Date: September 7, 2023  
To: TRPA Hearings Officer  
From: TRPA Staff  
Subject: Single-Family Residential Rebuild for North Shore TVCA LLC,  
6650 North Lake Boulevard, Tahoe Vista, Placer County, CA; Assessor's Parcel  
Number (APN): 117-072-006; TRPA File No.: ERSP2023-0707

**Requested Action:**

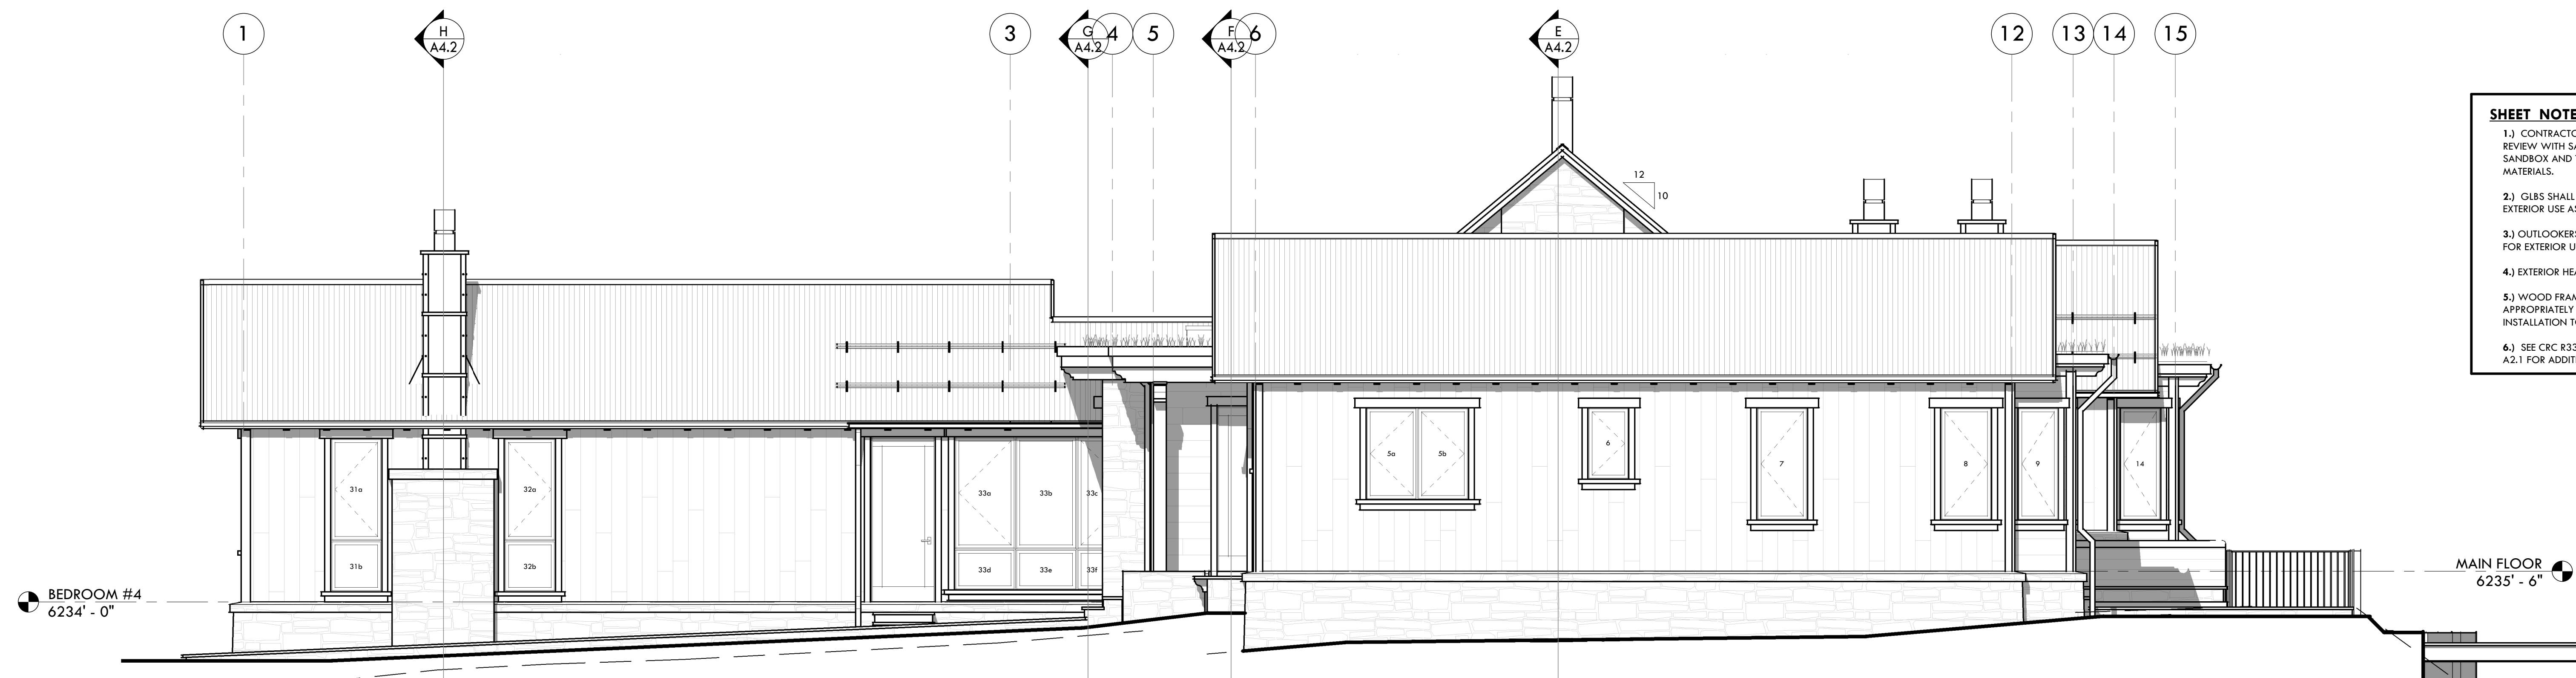
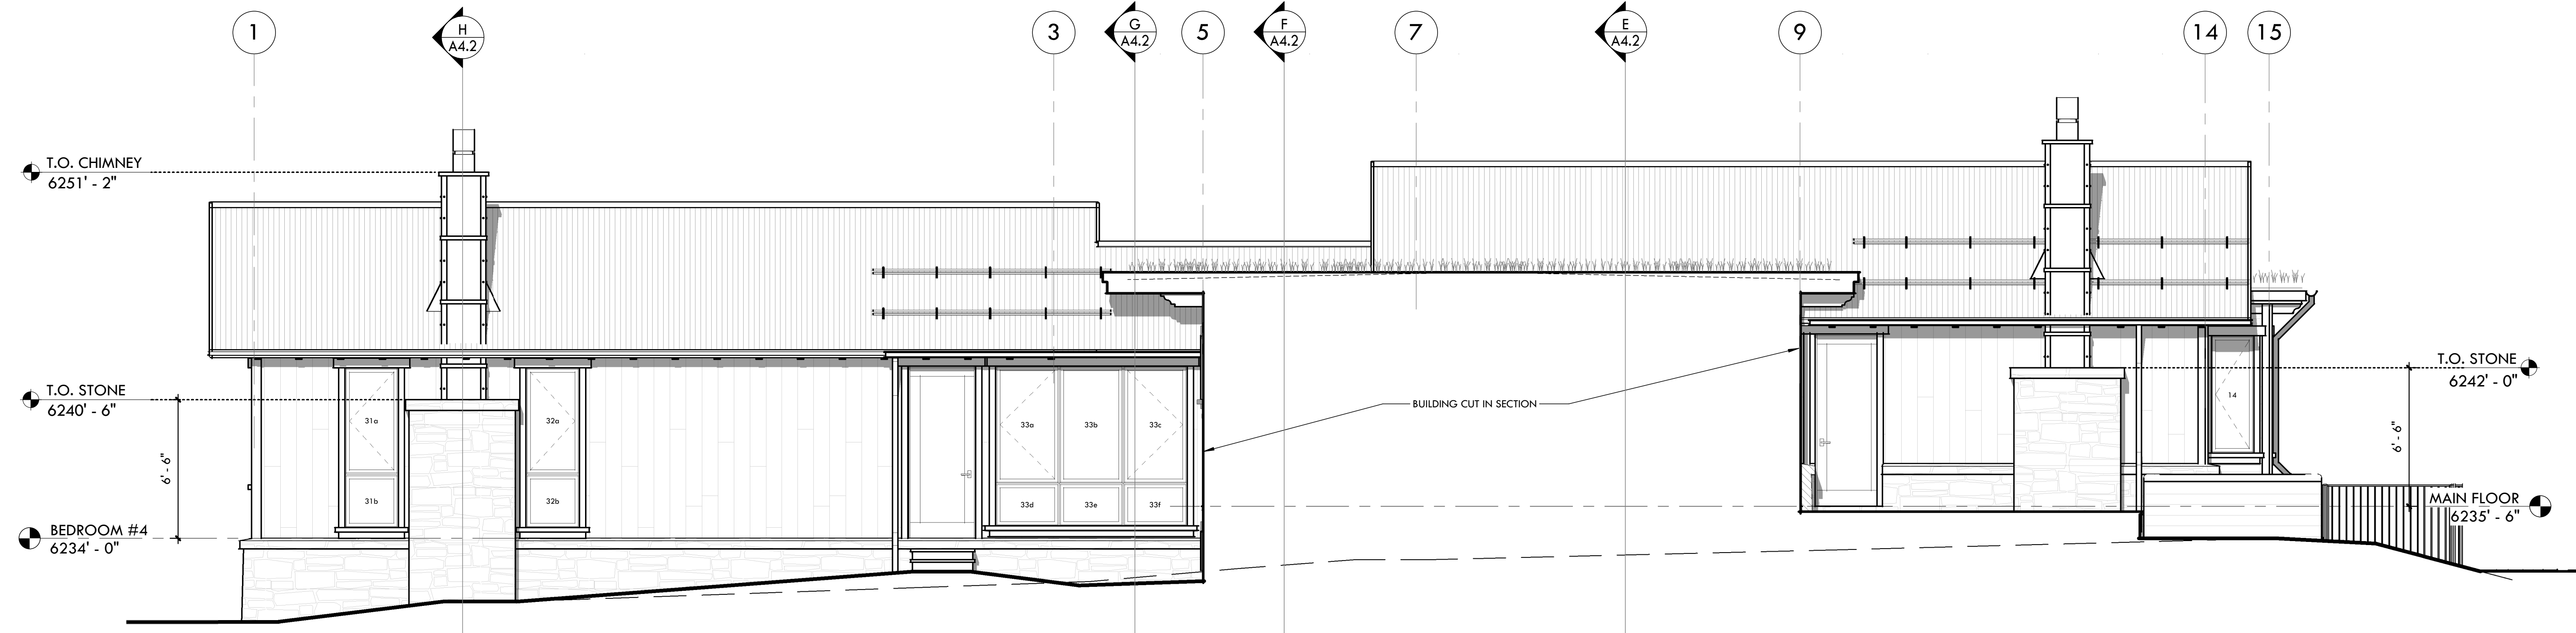
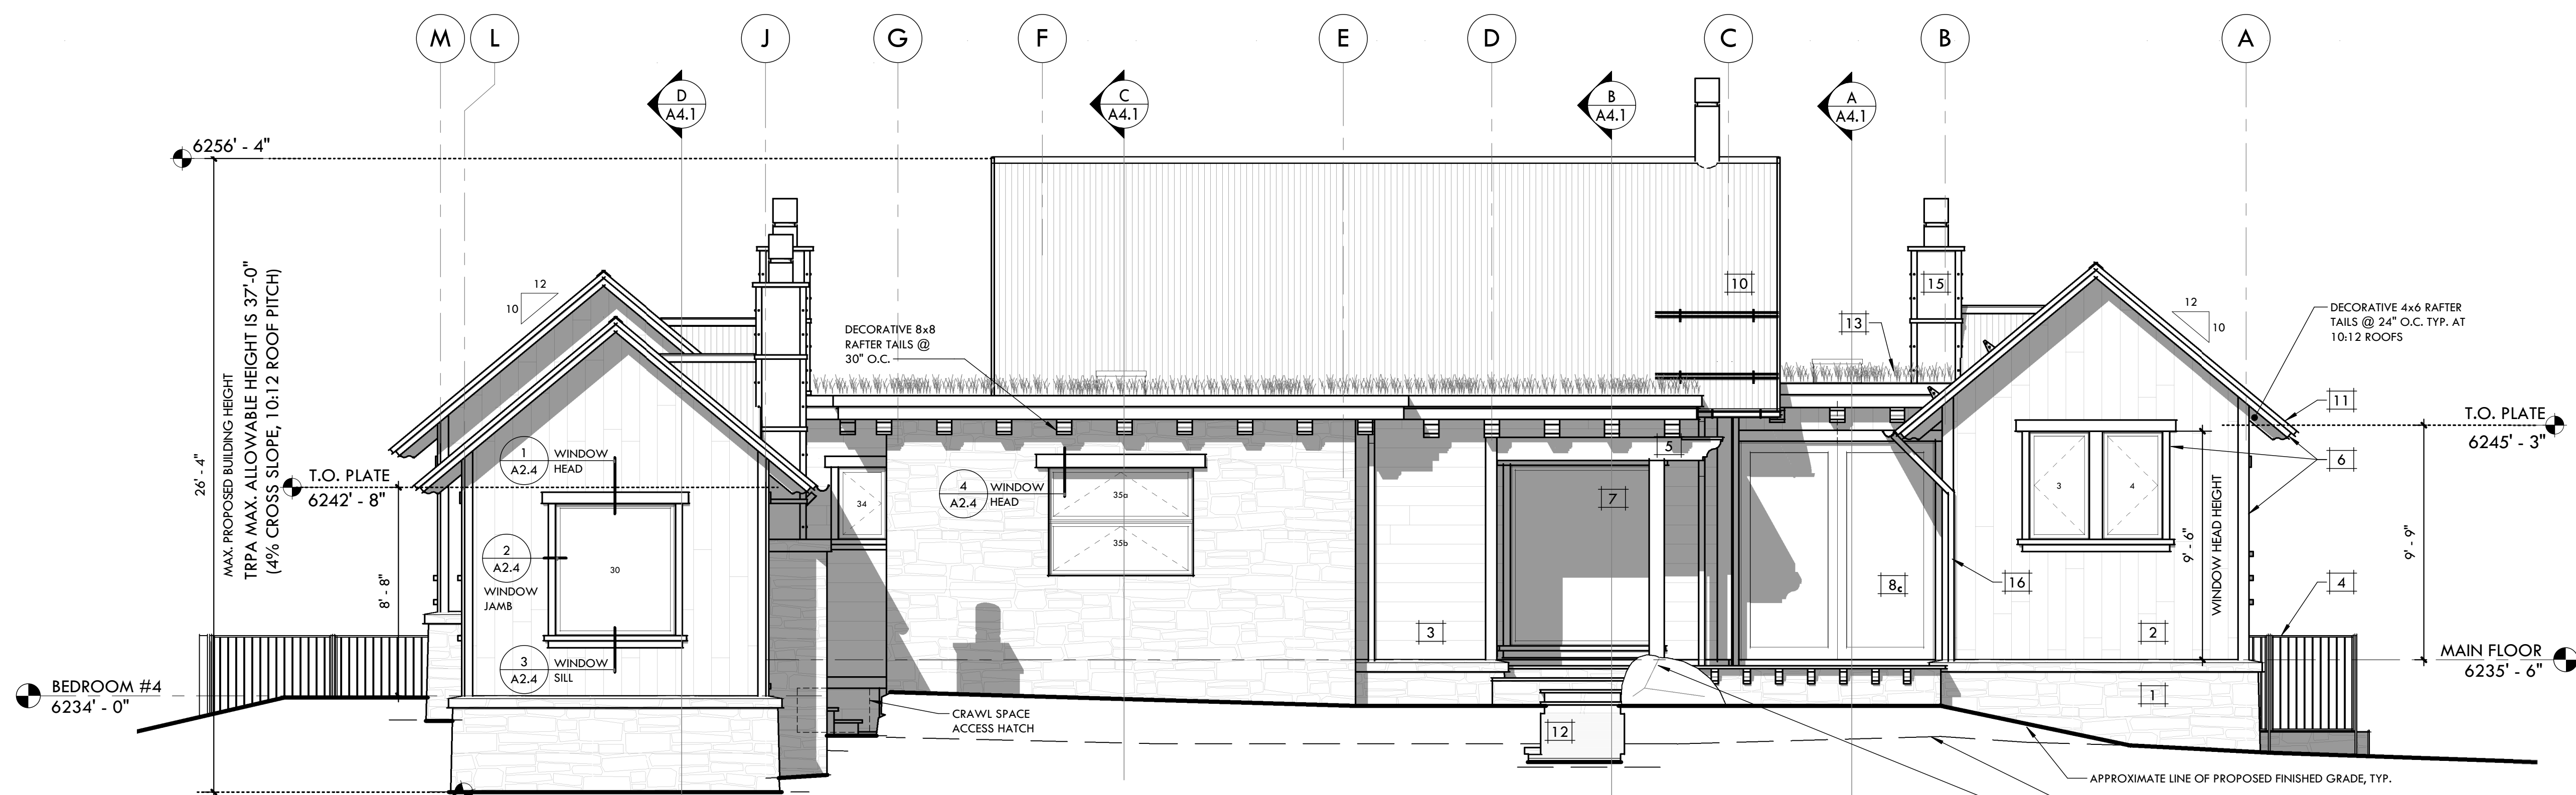
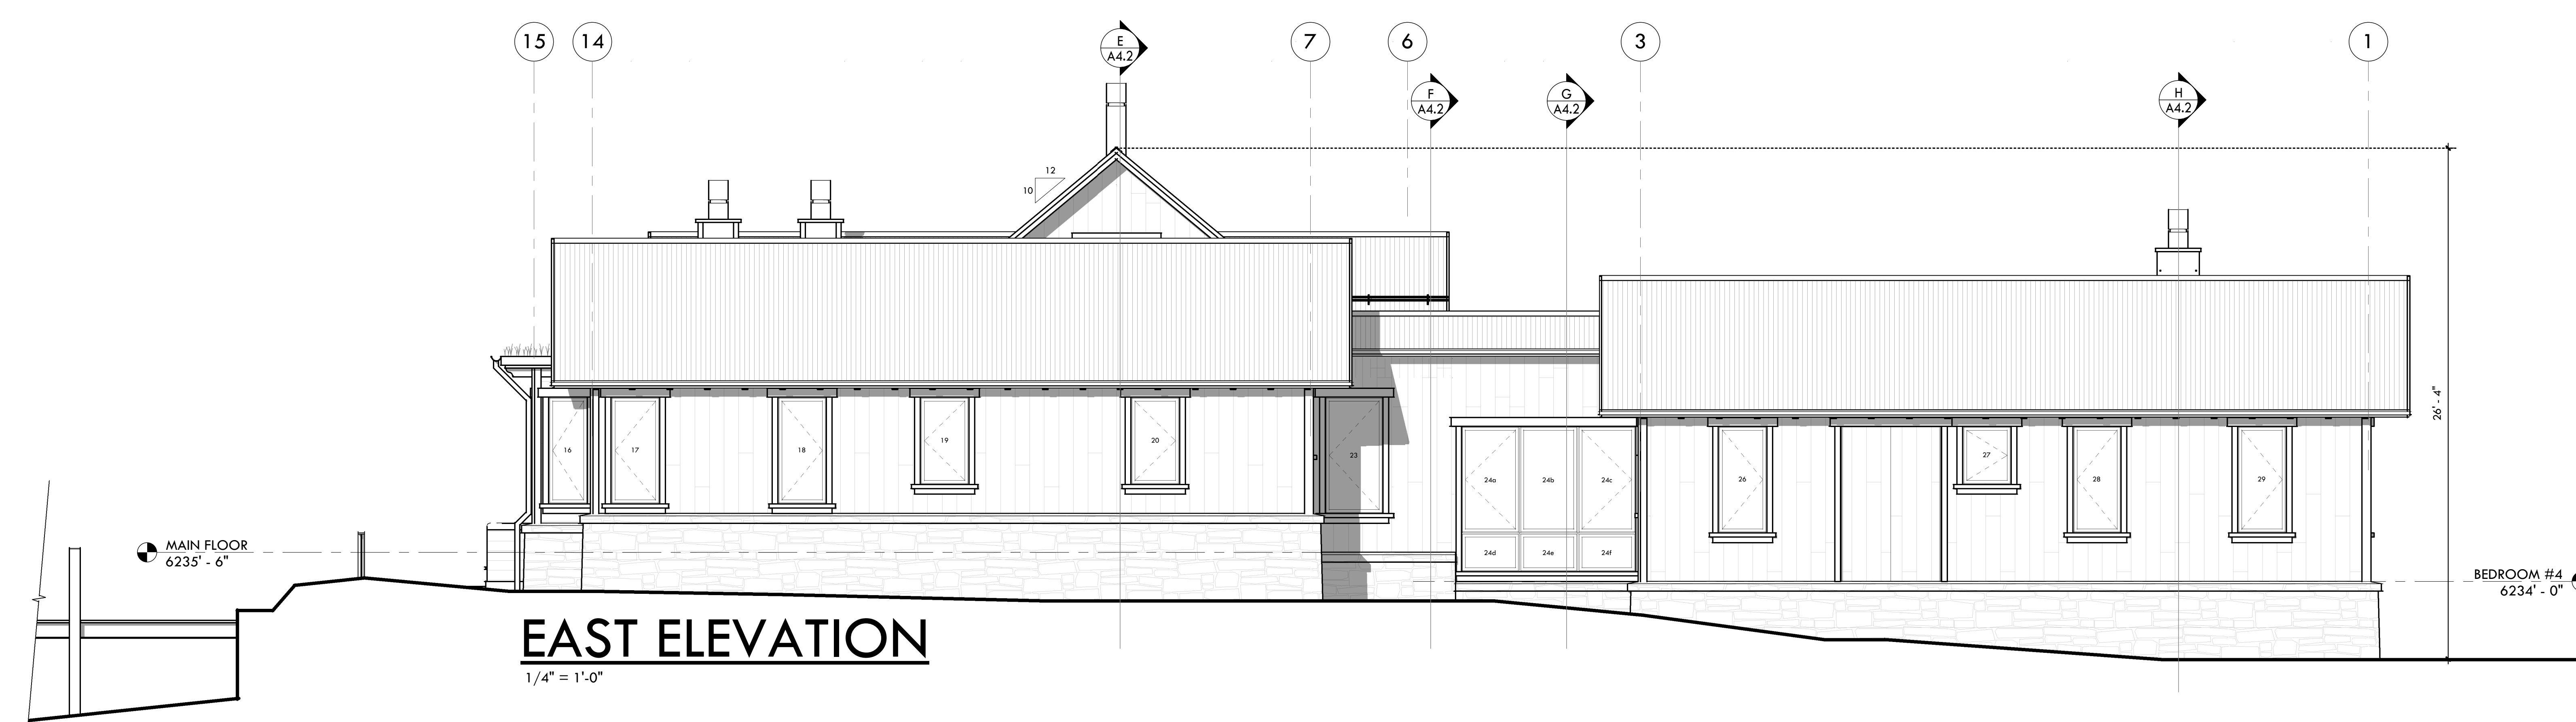
- (1) Show elevations of the bottom of foundations and support footings. Locate and label the maximum depth of excavation. Excavations shall not exceed 5 feet in depth and shall not extend below elevation 6,230,1’.

- (2) Provide additional material and color specifications for non-reflective (matte) paint or unfinished/weathering surfaces for the metal fence, metal roofing, exposed metal flashings/trim, metal chimney, and metal gutters/downspouts.

- (3) Specify 11 percent maximum reflectivity for the south elevation windows.
  - (4) Add notes on the garage and utility shed elevation sheets “Materials and colors for accessory buildings shall match materials and colors for the main house (see sheet A3.1).”
